KMR.CDD.GaQ.1926.02

With reference to ^{his}~~their~~ application dated...20-2-26...with a
 plan for the proposal ^{huts}~~Building~~
~~additional~~ on plot No. 1A Survey Sheet No. 5-2
 Garden Quarter Mr. H. P. Pathak is informed that
 until the following requirements are complied with the plans cannot be
 passed.

PLAN SHOWING TEMPORARY SHEDS ON PLOT NO. 1A. SHEET NO. 12 E.2 GARDEN QUARTER, KARACHI. SCALE 8"=1"

With reference to ^{his} ~~their~~ application dated 23/10/25 with aplan for the proposal ^{Shed} ~~Building~~ ^{additional} on plot No. 1A Survey Sheet No. E.2Garden Quarter Mrs. { Abdul Hussain Musabhoj
Abdul Rahim Jazabaly
Yusufali M. Bokkmanji } are informed that

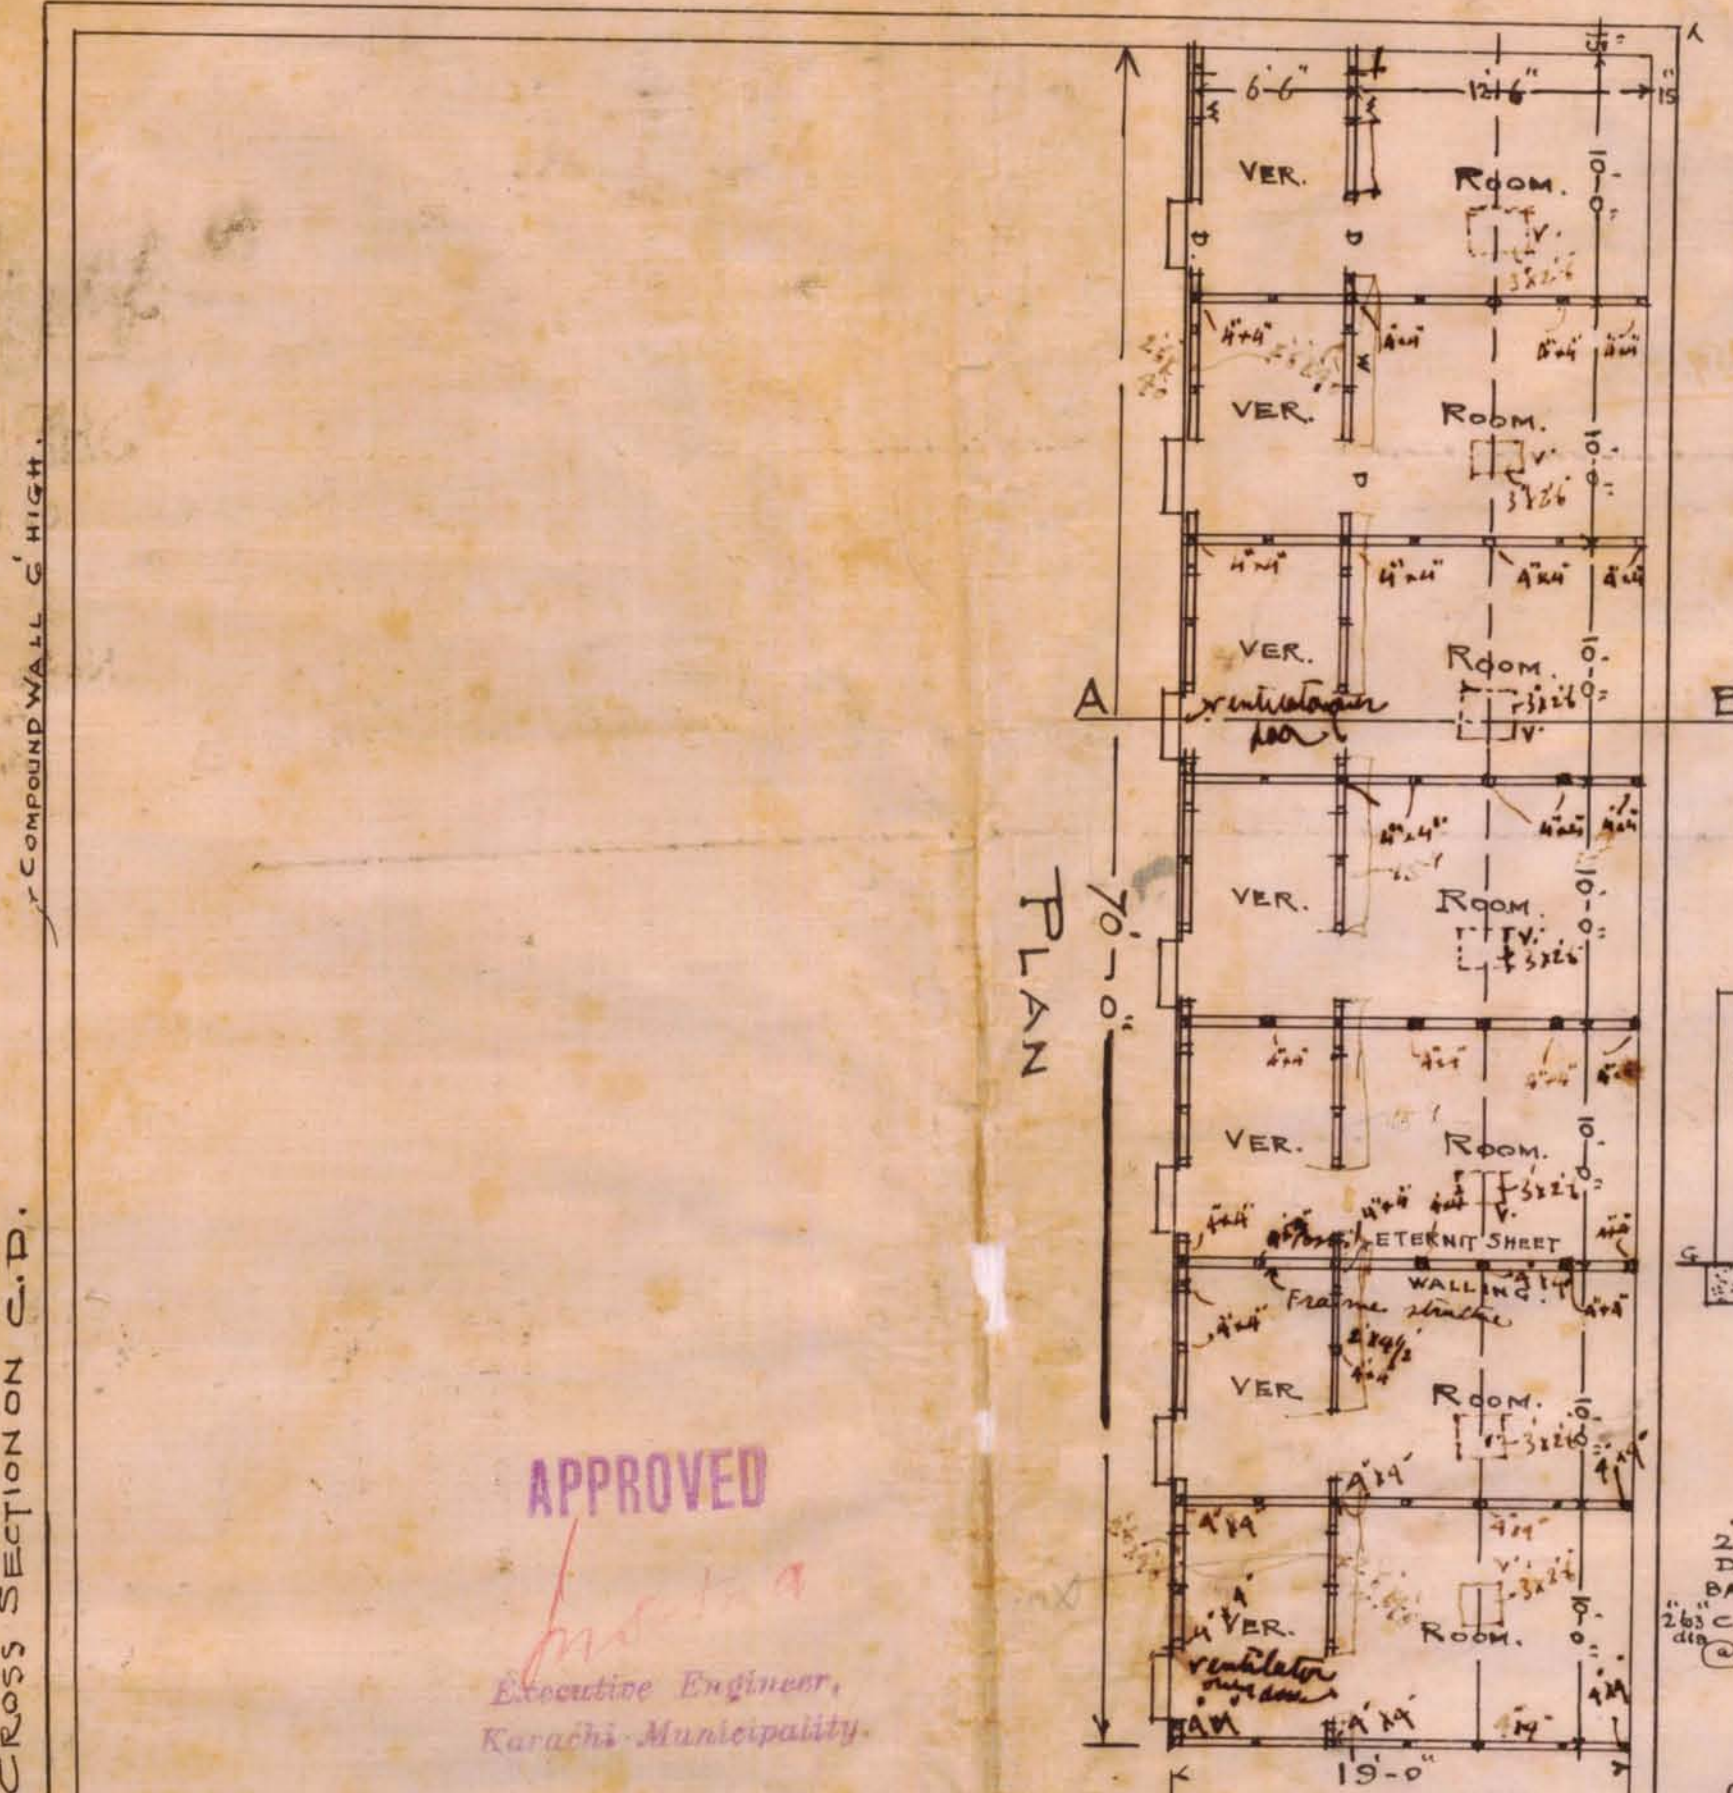
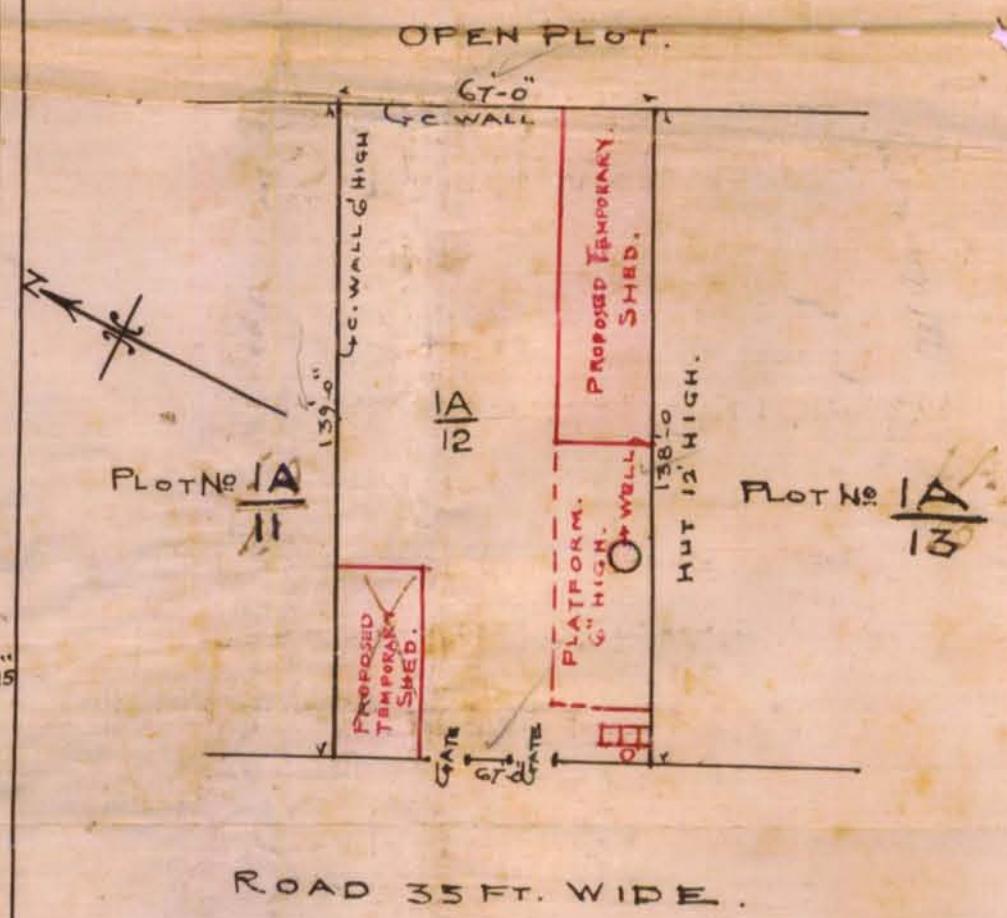
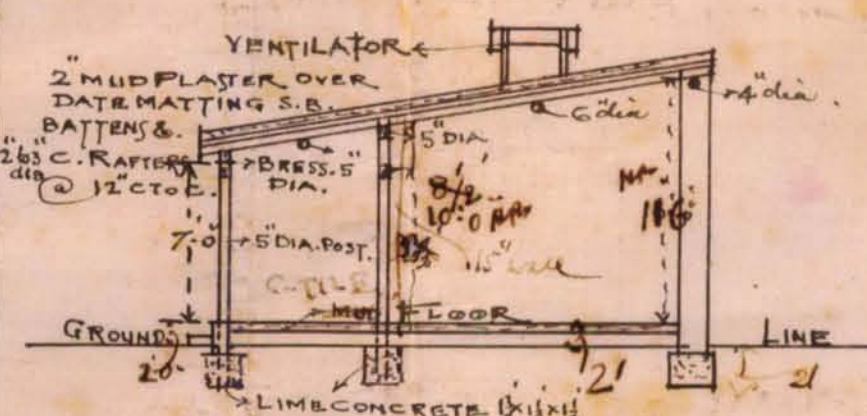
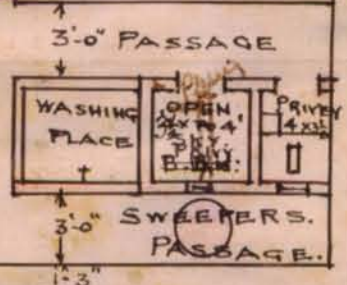
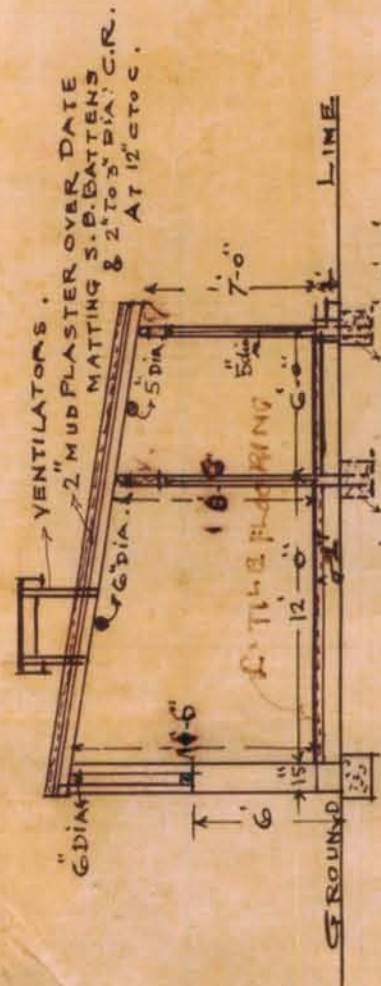
- (1) Agreement should be executed for
- (2) no Compensation in case the plot
- (3) comes under alignment.
- (4)
- (5)
- (6)
- (7)
- (8)
- (9)

- (1) Windows must be marked with their size.
- (2) Plinth must be 2'.
- (3) Height must be made 10' for the rooms.
- (4) The sheds are provided.
- (5) Plinth is made 1' higher than my opinion is not objectionable.
- (6) The height of sheds are shown.
- (7) Ventilator are shown on the shed towards the East.
- (8) They are not.
- (9) The plan of the shed is not.

- (1) The shed to be erected temporarily for a period
of three years.
- (2) The partitions are shown as framed over.
- (3) Three primies are provided.
- (4) As the sheds are of the nature of huts the
plinth is made 1' higher than g.l. level which
in my opinion is not objectionable.
- (5) The height of sheds are shown as 10'0" &
8'6" the least as required.
- (6) As ventilators are shown on the roof and as
the plot towards the East belongs to some other
person, they are not provided towards the East.
Foundation of framed work is shown as
required.
- (7) As the structures are temporary the

PLAN SHOWING TEMPORARY
SHEDS ON PLOT NO. 1A. SHEET NO. 12 E. 2.
GARDEN QUARTER, KARACHI.
SCALE 8"=1"

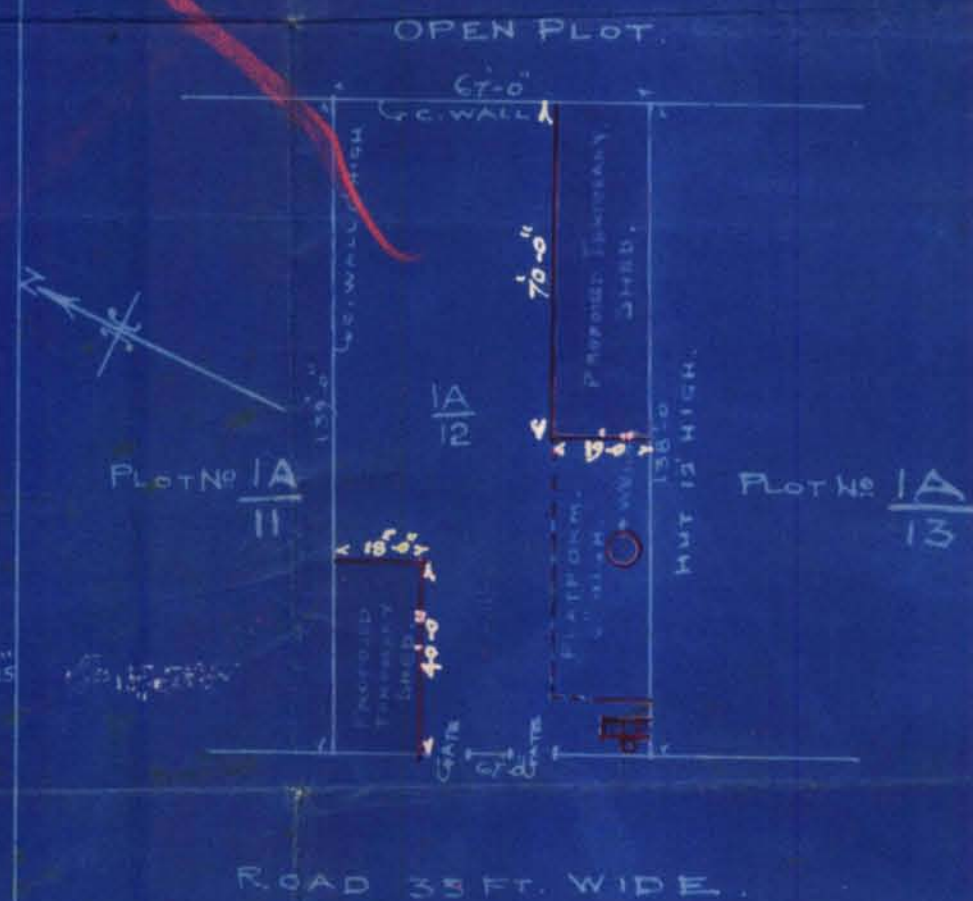
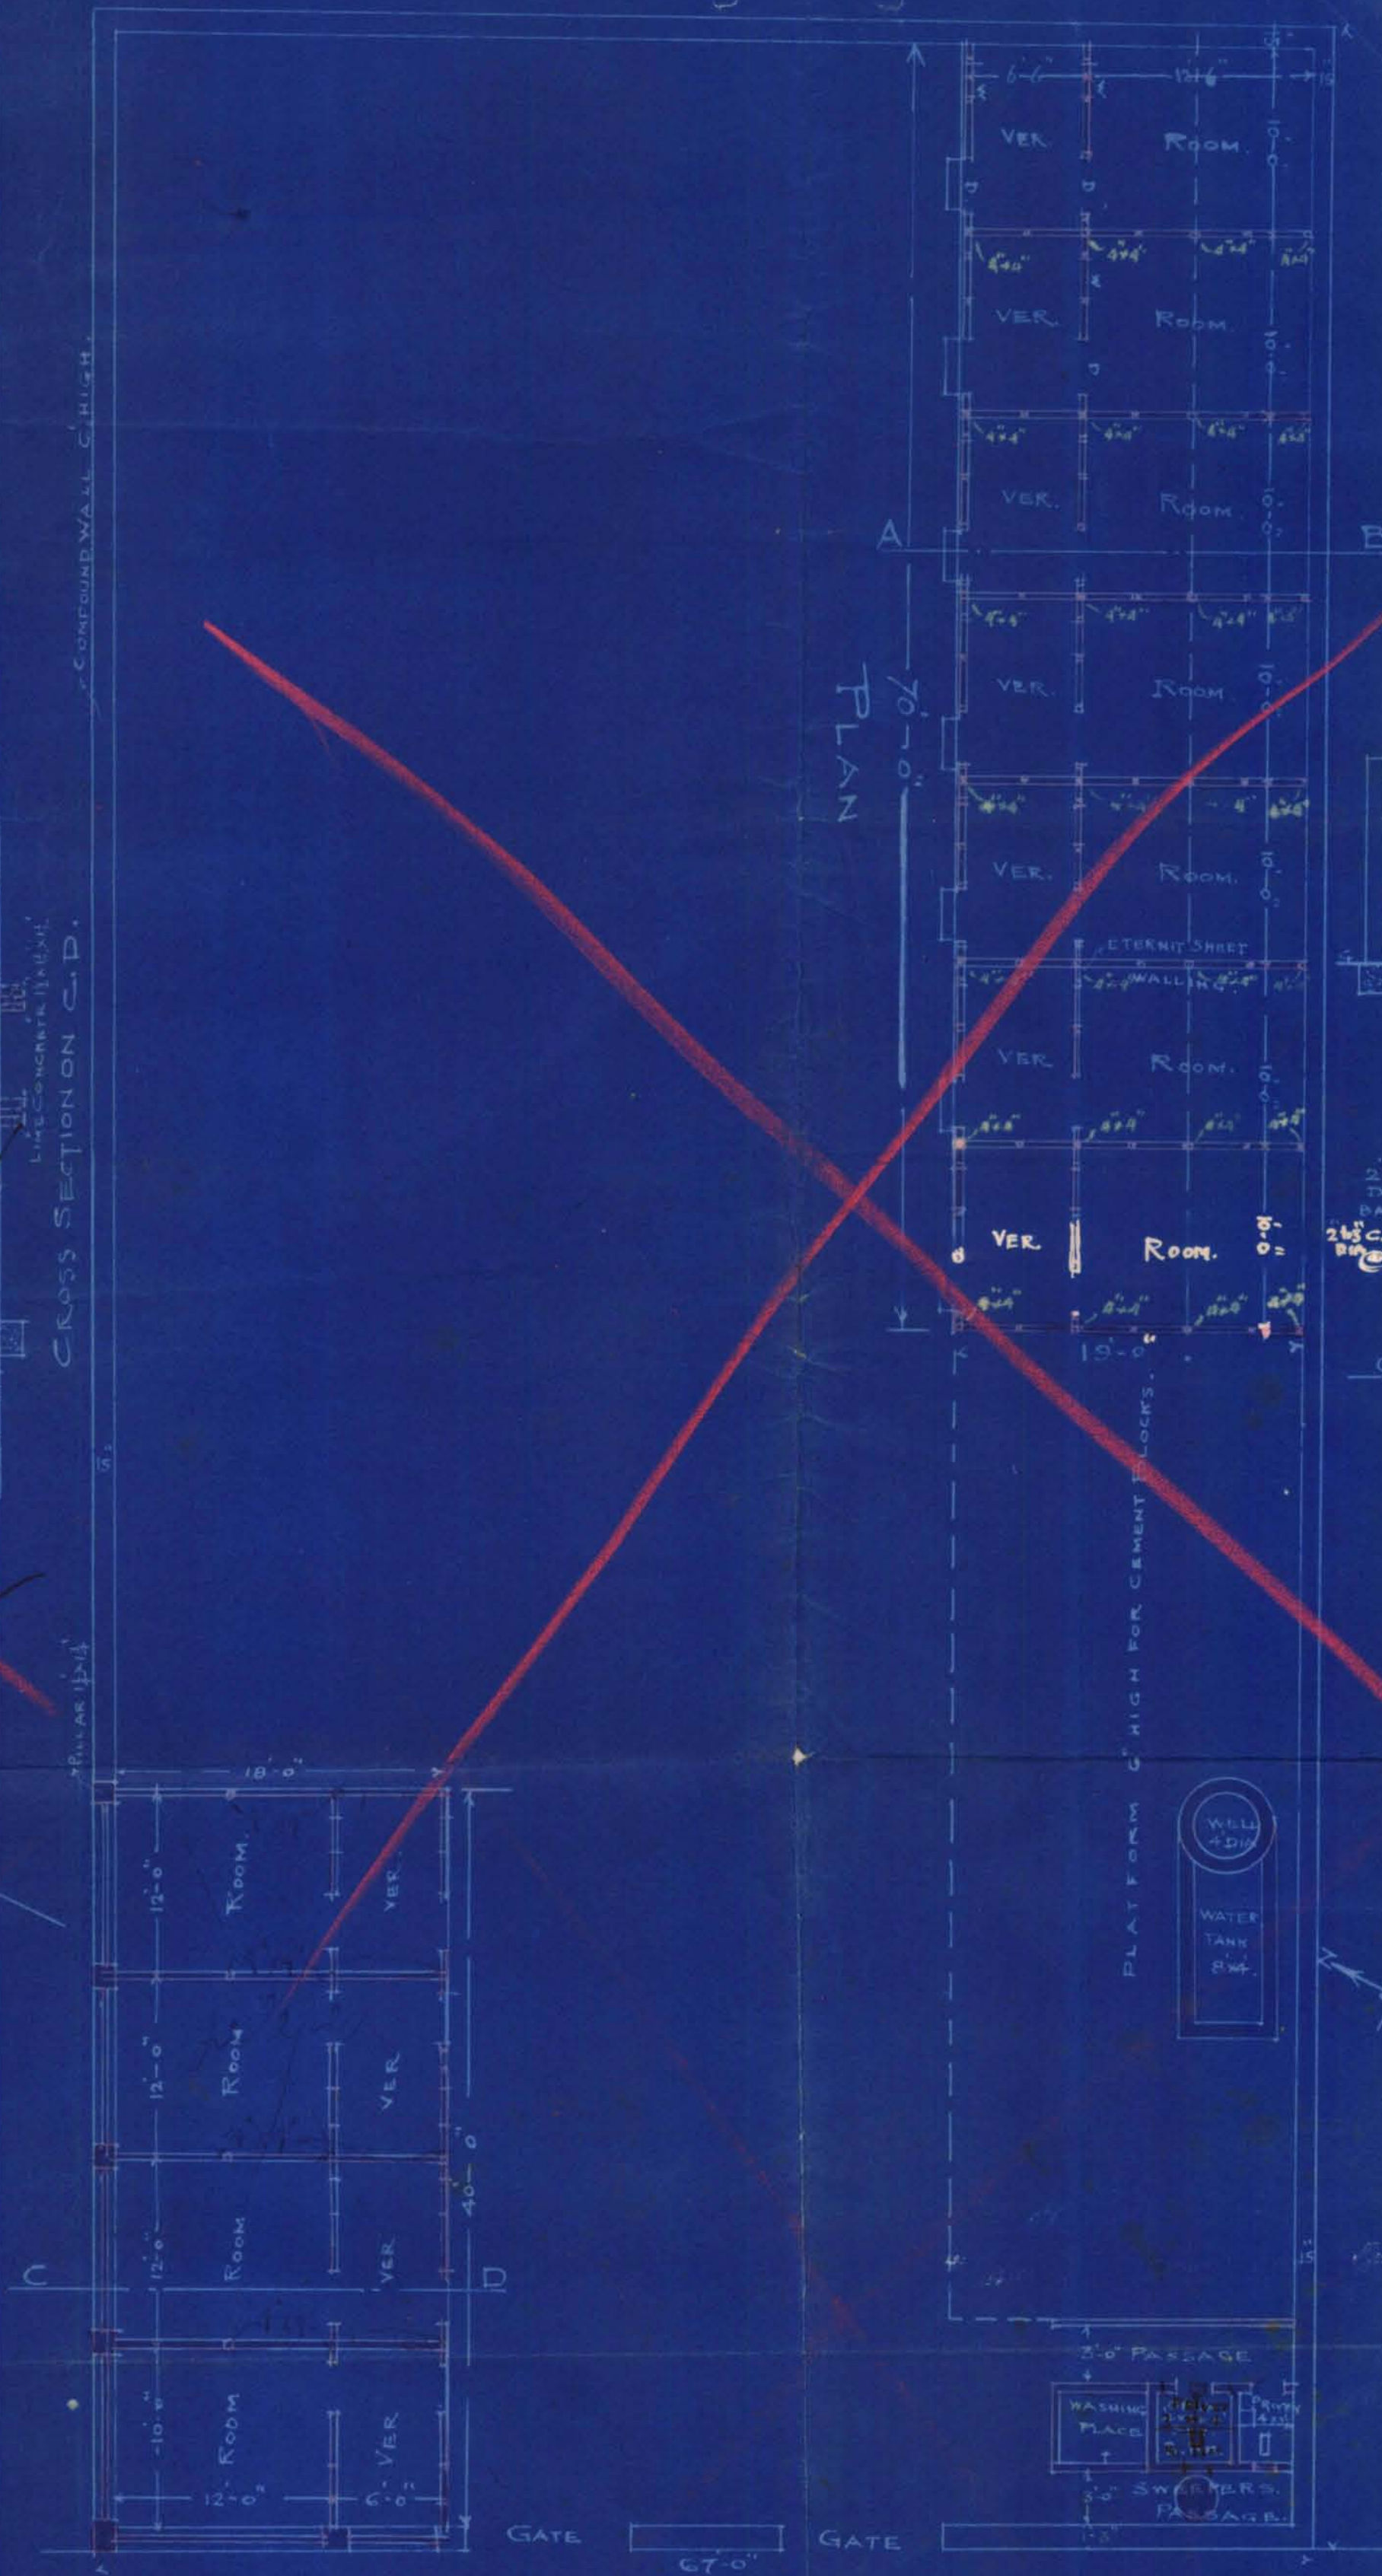
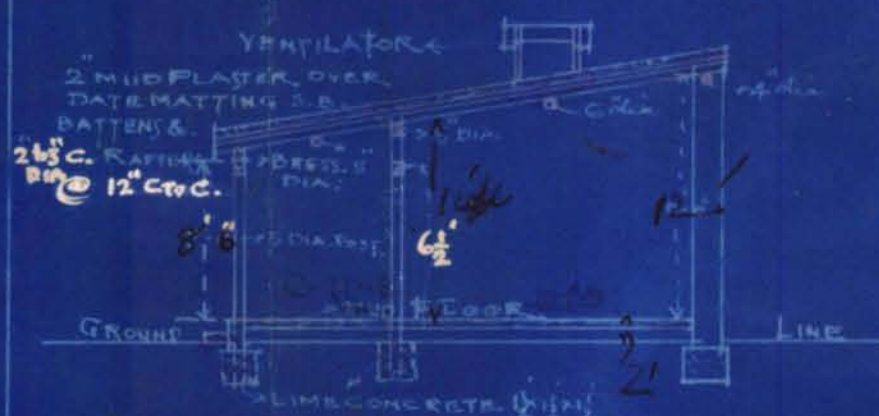
- (1) If the sheds are temporary, please give period after which they will be demolished. removed.
- (2) Partition walls if not made of pucca walls, a design for a framed structure should be submitted.
- (3) Three privies are necessary.
- (4) Height of plinth must be 2 feet.
- (5) The below states that the least height of living rooms should be 8'; whereas the height given is 7'. The clear height in living room should be 10' as the rooms are ill-ventilated.
- (6) Windows on East wall should be shown with sizes.
- (7) Foundation should be taken to hard soil.
- (8) External walls must be made pucca.
- (9)

- (1) If The Sheds are temporary, please give period after they will be demolished. removed.
- (2) Partition walls if not made pucca, a design for a structure should be submitted.
- (3) Three privies are necessary.
- (4) Height of plinth must be 2 feet.
- (5) The below states that The least height of living rooms should be 8'; whereas The height given is 7'. The clear height in living rooms should be 10', as the rooms are ~~illventilated~~ ^{are} illventilated.
- (6) Windows on east wall should be shown with sizes.
- (7) Foundation should be taken to hard soil.
- (8) ~~External walls must be made Pucca~~
- (9)

- (1) The middle partition walls are not provide pucca
- (2) The plinth is not made 2' as required.
- (3) The height of the room is average more than 8' and ~~so~~ can be allowed without any objection
- (4) Two fireplaces are now provide instead of three required to be provides
- (5) Depth of foundation is given as 1'-6"
- (6) These sheds in fact are "temporary" living rooms and as such the question re partition wall
- (7) and plinth maybe reconsidered.
